METRO PLANNING COMMITTEE OF THE TOWN PLANNING BOARD

MPC Paper No. 10/16

**Submission for Compliance with
Approval Condition (a) of Application No. A/K20/126**

**Proposed Public Utility Installation (Dry Weather Flow Interceptor)
in “Open Space” Zone and area shown as ‘Road’
Government Land, Hoi Fai Road, Tai Kok Tsui, Kowloon West**

繪圖
DRAWING
AA - 3

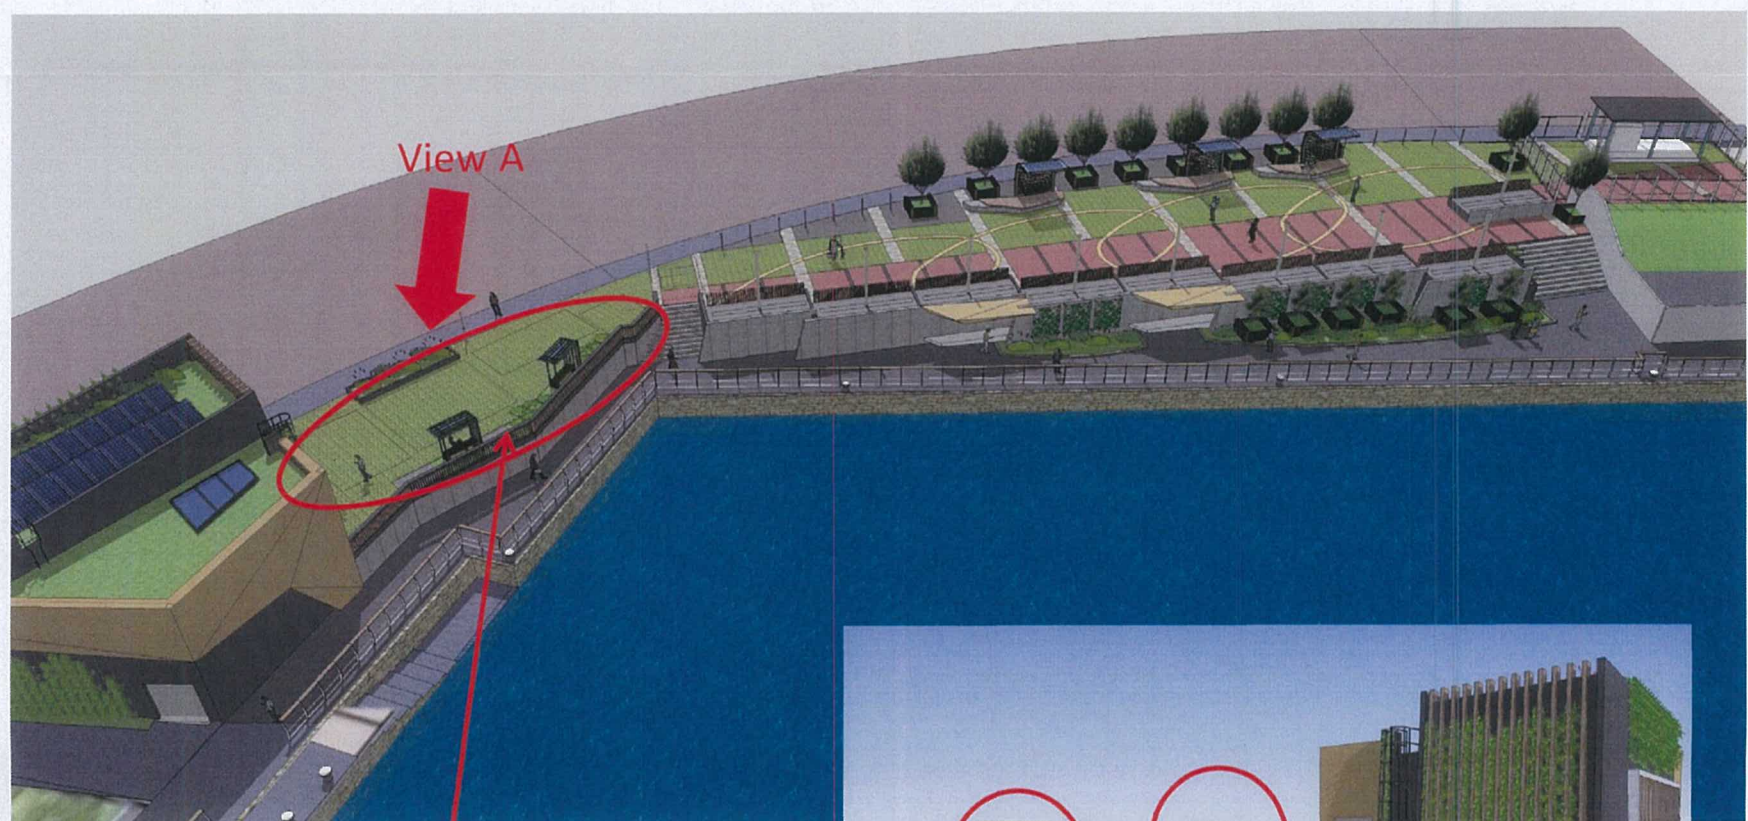
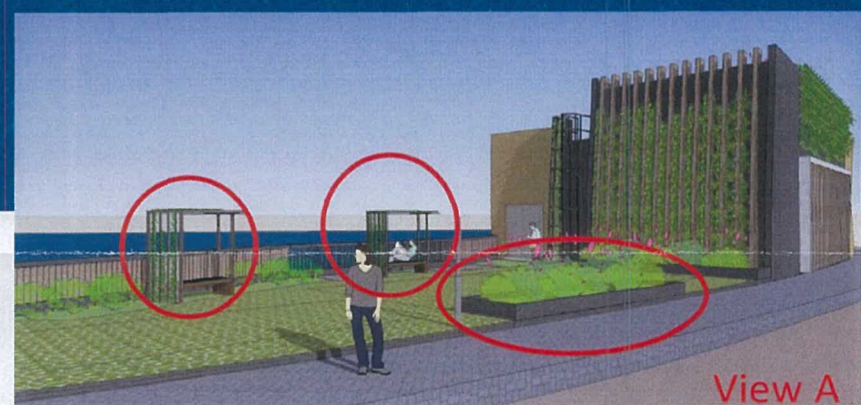
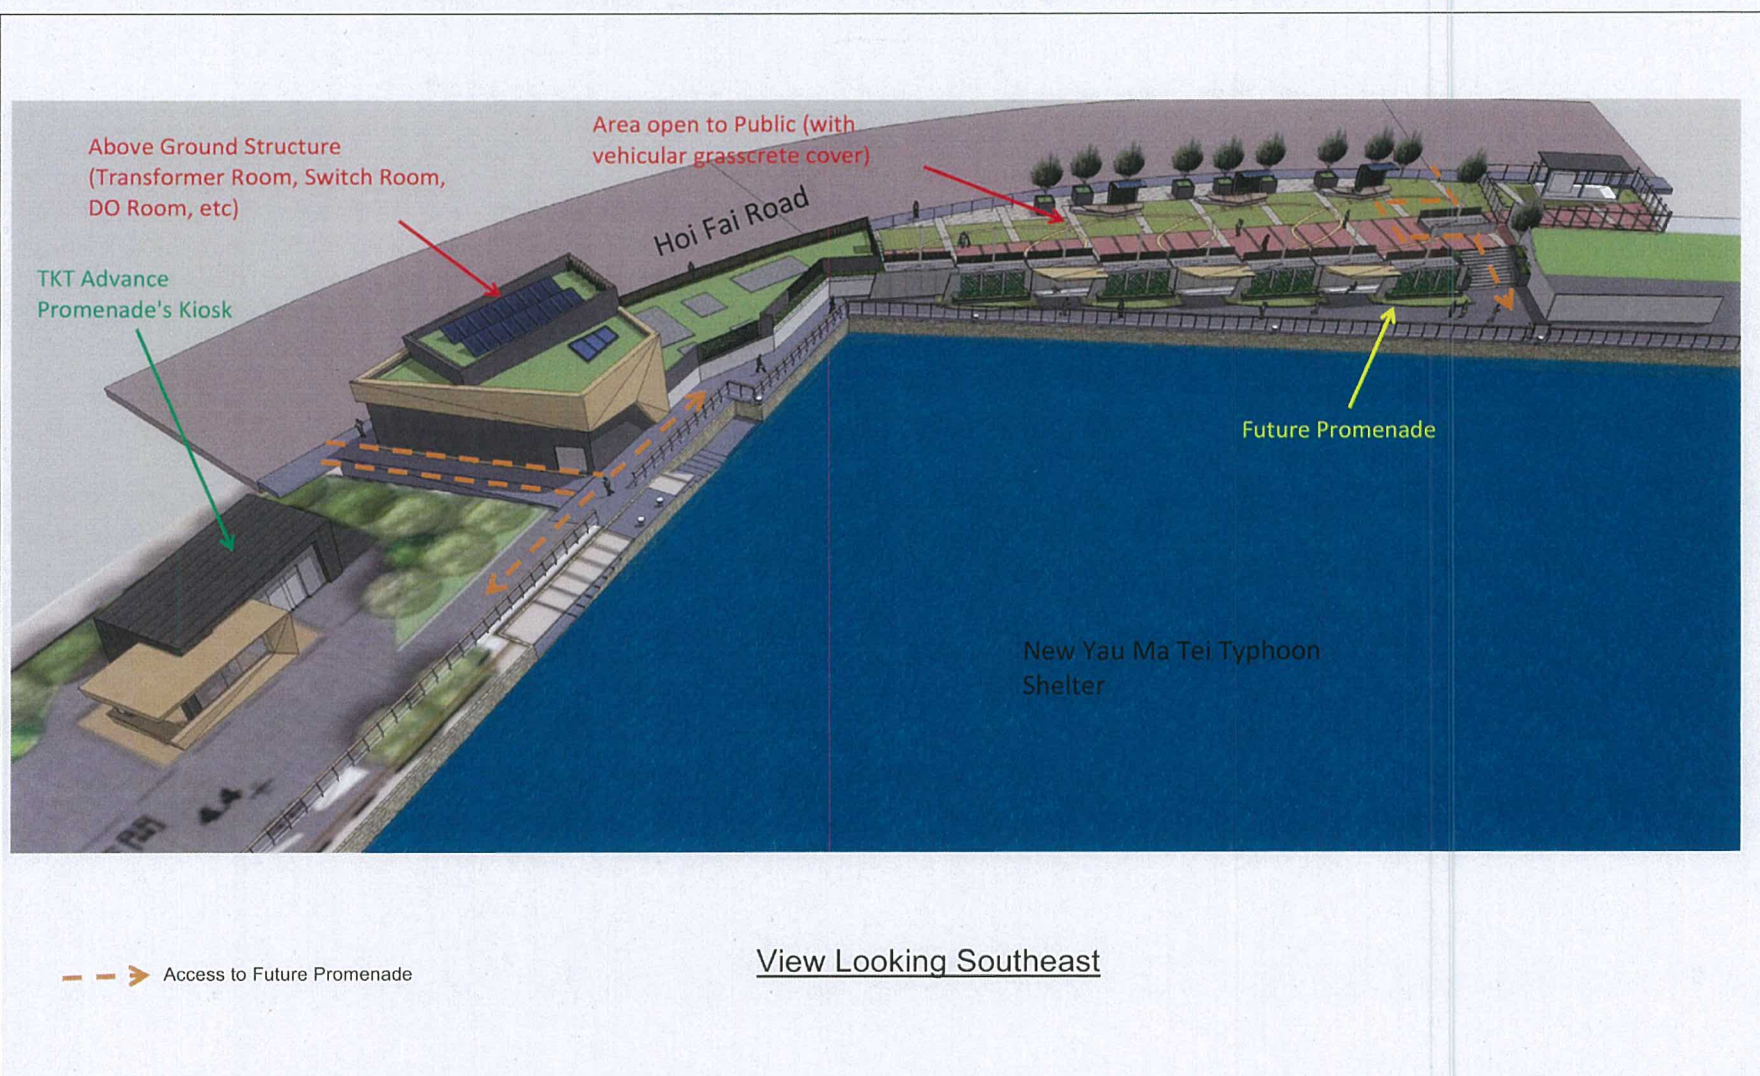
- (c) The fence wall above the underground pumping station has been removed in the revised design to enhance visual openness (**Drawing AA-3**) (but will be fenced off during maintenance works and screenings removal for safety reasons) and to maximise the provision of open space. Approximately 90% of the Site will be opened to public.
- (d) Due to operational needs and inadequate space/soil depth for tree planting at the newly opened up area, grasscrete and removable planters with shrubs and benches with shelter are proposed above the underground pumping station for public enjoyment, as the covers would need to be opened frequently for accessing the underground facilities and for carrying out regular maintenance works and screenings removal by trucks (about 3 times per week).

- 6.2 The original fence wall above the underground pumping station in the northern part of the Site has been removed to enhance visual openness and maximise the provision of open space (**Drawing AA-3**) (except during maintenance and screenings removal for safety reasons).

Fence wall removed to enhance visual openness and for public enjoyment

Removable planter with shrubs and benches with shelter added to improve the streetscape and amenity of the vicinity

參考編號 REFERENCE No. A/K20/126	繪圖 DRAWING AA - 4
---	--------------------------------

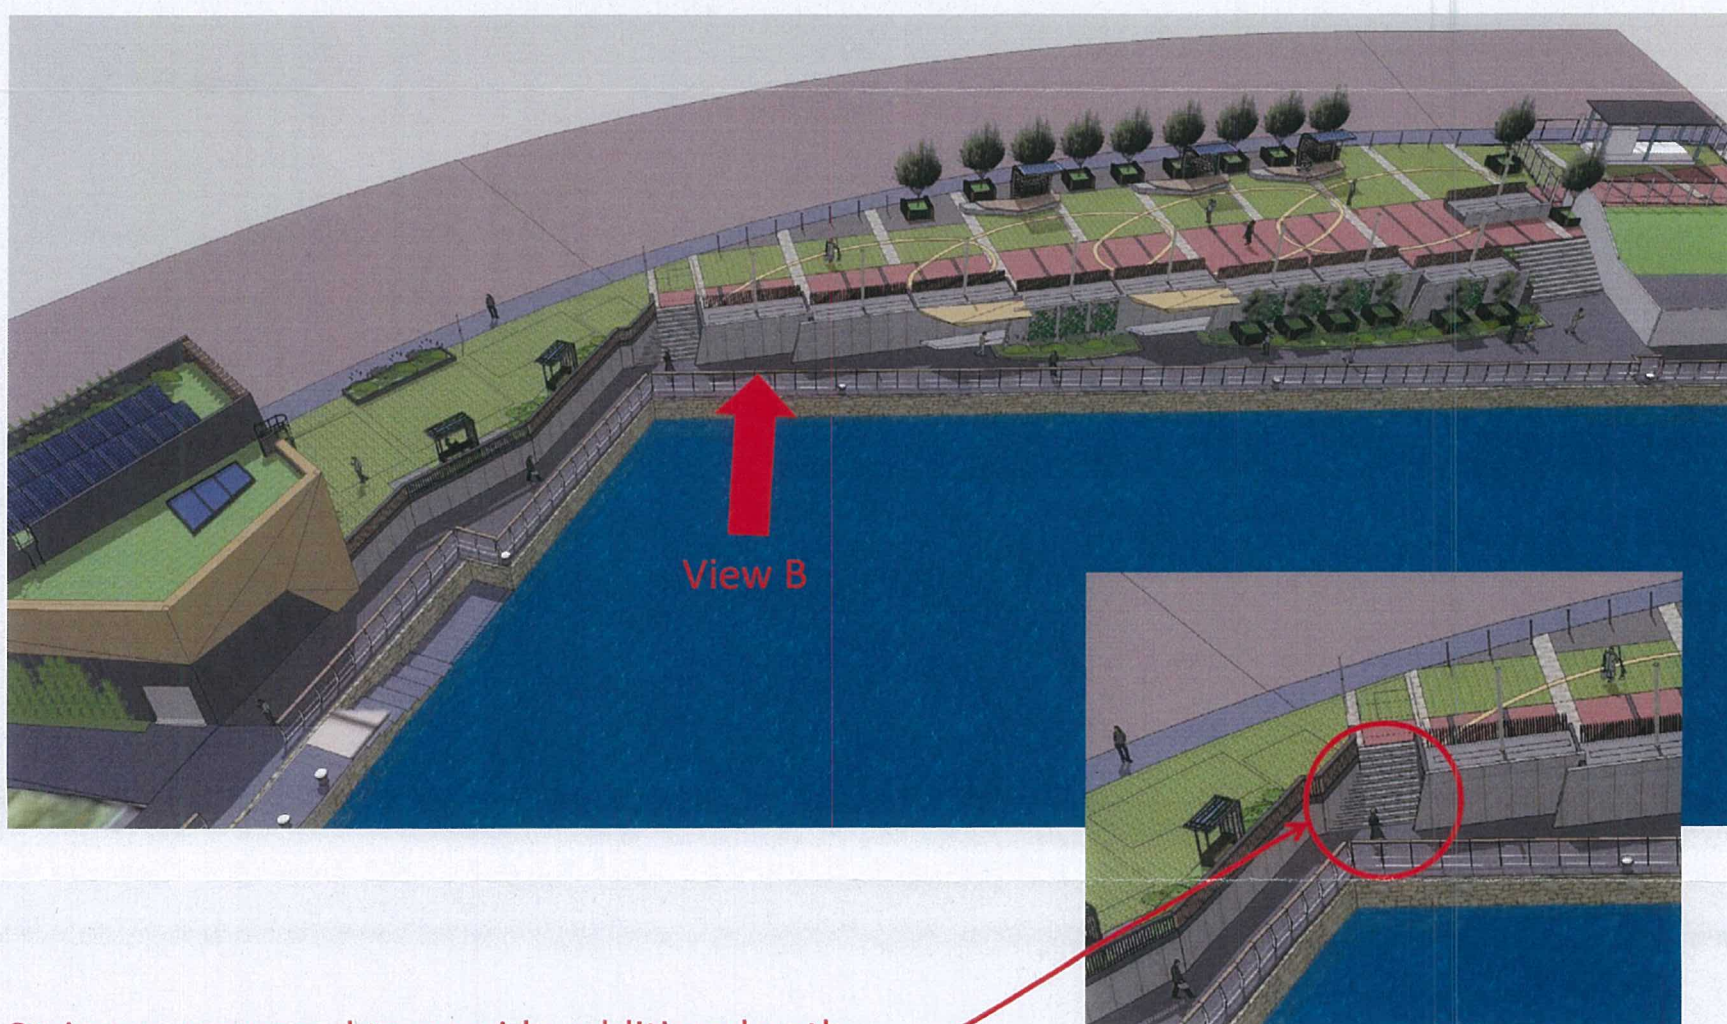
Staircase proposed to provide additional path to enhance pedestrian flow

參考編號 REFERENCE No.	繪圖 DRAWING
A/K20/126	AA - 5

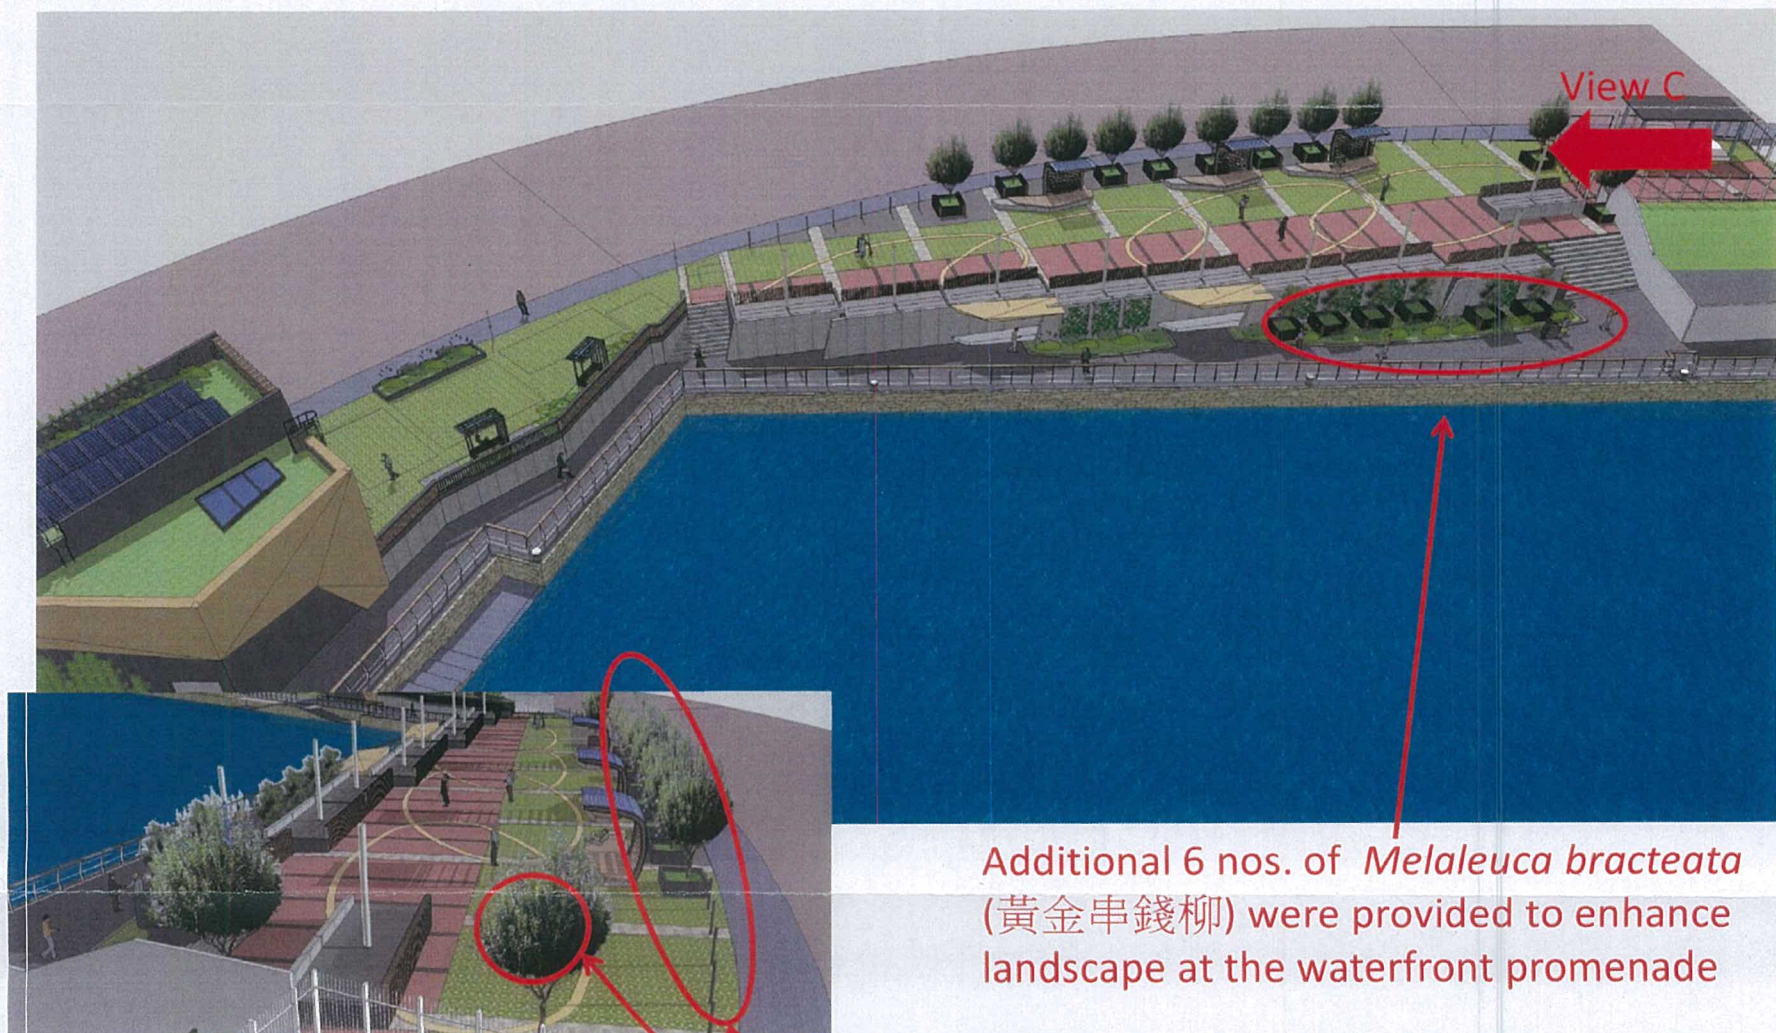
- (g) Shrubs will be planted at the promenade to improve the appearance of the planters and six additional trees on removable planters, *Melaleuca bracteata* (黃金串錢柳) (**Drawing AA-5**) have been proposed towards the southern side of the waterfront promenade, in addition to the proposed shelters, landscape area and vertical green walls under the original scheme, in order to maximise tree planting opportunities along the promenade (**Drawings AA-2 and AA-5**).

- (h) The planter boxes will be designed to enhance visual appearance matching with the environment. The height of all tree planter boxes have been reduced and semi-sunken to a height of 0.75m above ground to look less massive and enhance visual openness while complying with the required soil depth of 1.2m (**Drawings AA-2 and AA-5**).

參考編號 REFERENCE No. A/K20/126	繪圖 DRAWING AA - 6
------------------------------------	-------------------------

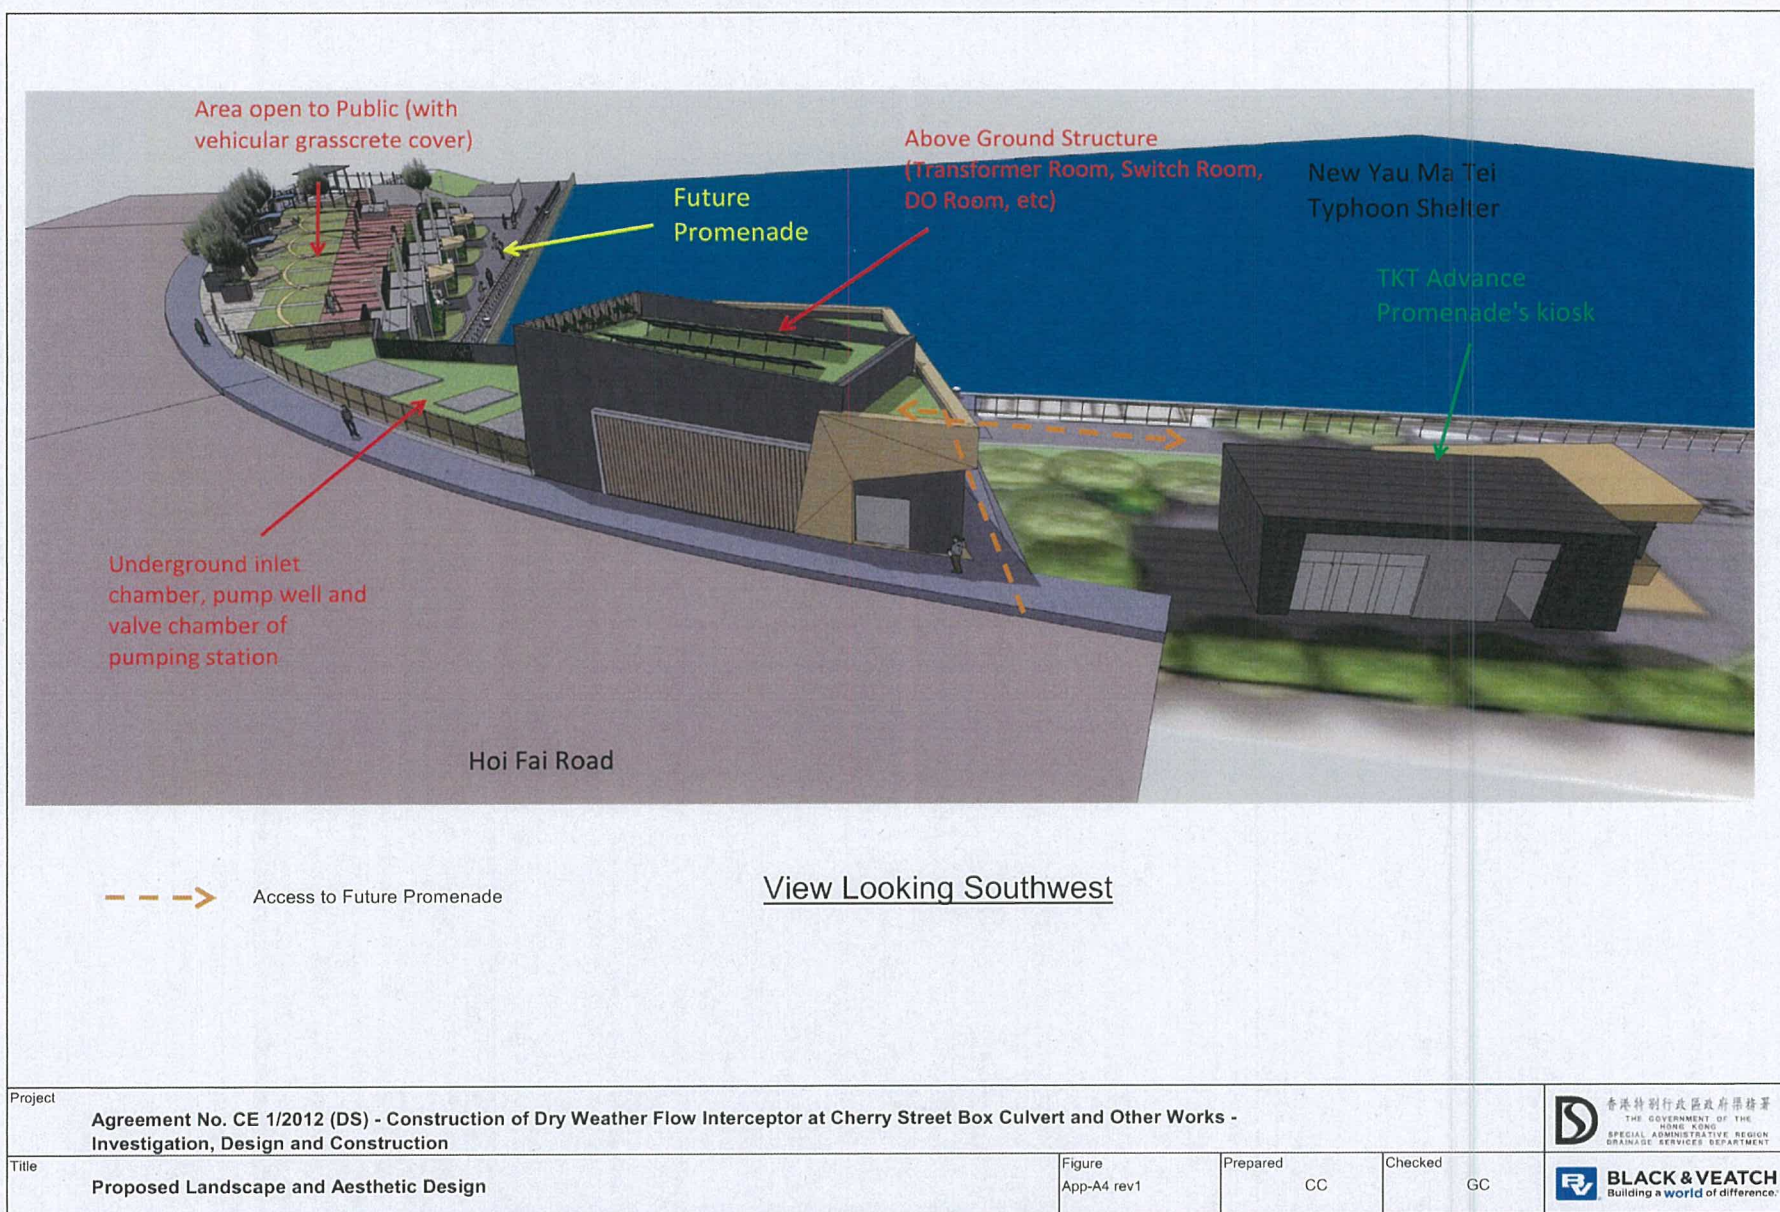
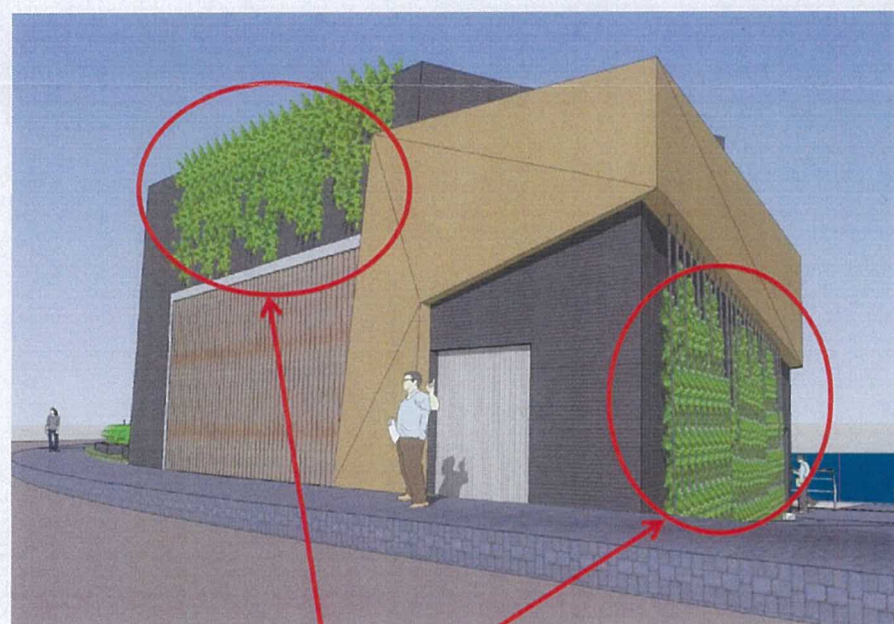
- (f) As suggested by the Architectural Services Department, additional vertical greening will be provided at the northern and western façade of the pumping station to further soften the building mass (**Drawing AA-6**).

- 6.5 Additional landscaping and greening measures have been proposed, including vertical greening at the northern and western façade of the pumping station to further soften the building mass (**Drawing AA-6**), provision of shrubs at the promenade to improve the appearance of the planters and addition of trees on removable planters, landscape area and vertical green walls to maximise tree planting opportunities (**Drawings AA-2 and AA-5**). The height of all tree planter boxes has also been reduced and semi-sunken to a height of 0.75m above ground to reduce the mass and enhance visual openness (**Drawings AA-2 and AA-5**).

Vertical greening is added on the northern and western façade of the building
